## **Proposal for the 11 series of amendments to UN Regulation No. 17 (Strength of seats)**

### **Submitted by the expert from the Norway**

The modifications related to Annex 9 of the UN Regulation are marked in bold for new characters. The change is adding a paragraph 2.1.1.8 and change in the illustration and text in Figure 1 under the same paragraph.

Figure 1  
Positions of test blocks and dummies before test of rear seat-backs

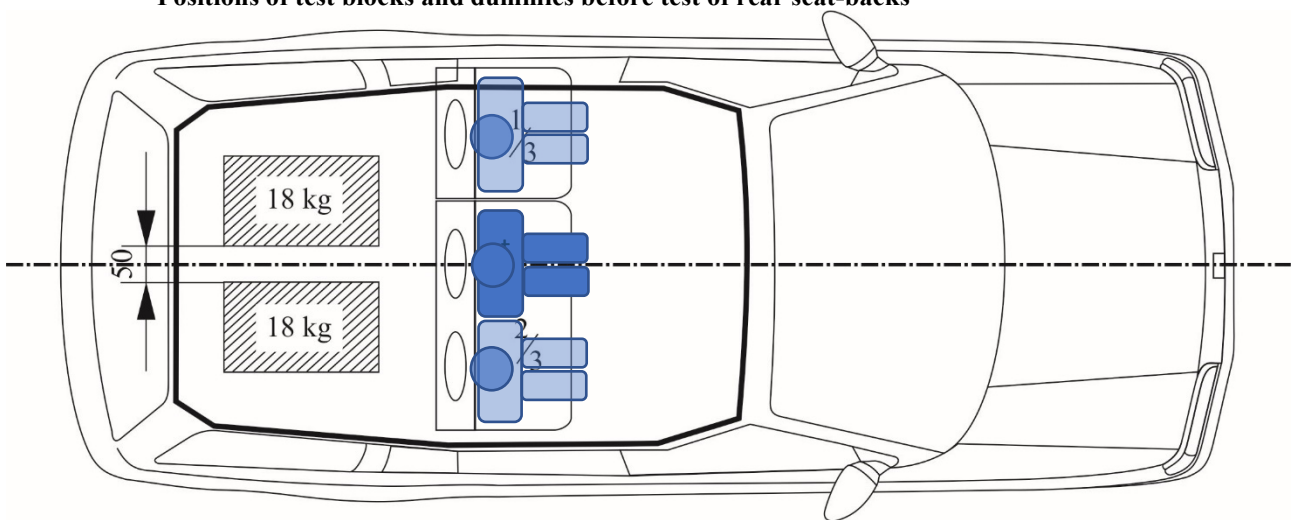
**2.1.1.8. For seat(s) with integrated upper seat belt anchorage point, a 50<sup>th</sup> percentile male dummy shall be placed in rear seat(s) fitted with all components of its safety-belt. The dummy does not have to be instrumented. Other suitable test-manikins with equal mass can be used after agreement between the Technical Service/Type Approval Authorities and the manufacturer. (see Figure 1)**
